EuCARD-WP7-HFM

ESAC Review

Task 3 : High Field Magnet

***Responses to the
recommendations of the second
ESAC dipole review***

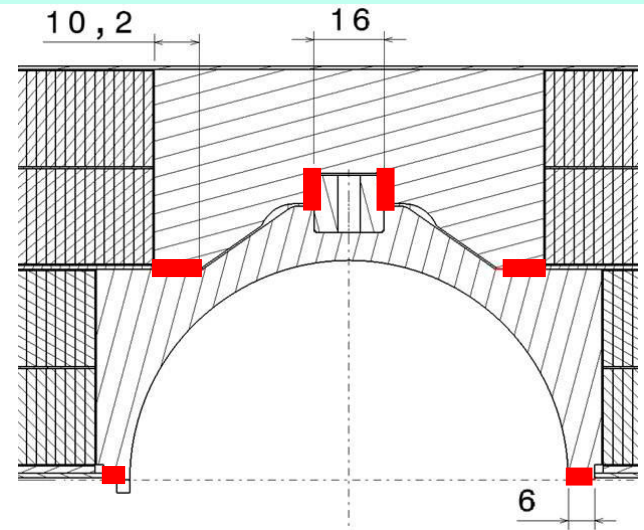
R2: The contribution of the proposed alignment to the inner structural rigidity should be calculated and compared

R3: The interaction (displacements) between the inner layer pole and the outer layer island should be looked at

- Contacts and centering are shown in the figure beside
- Contact are taken into account in FE calculations
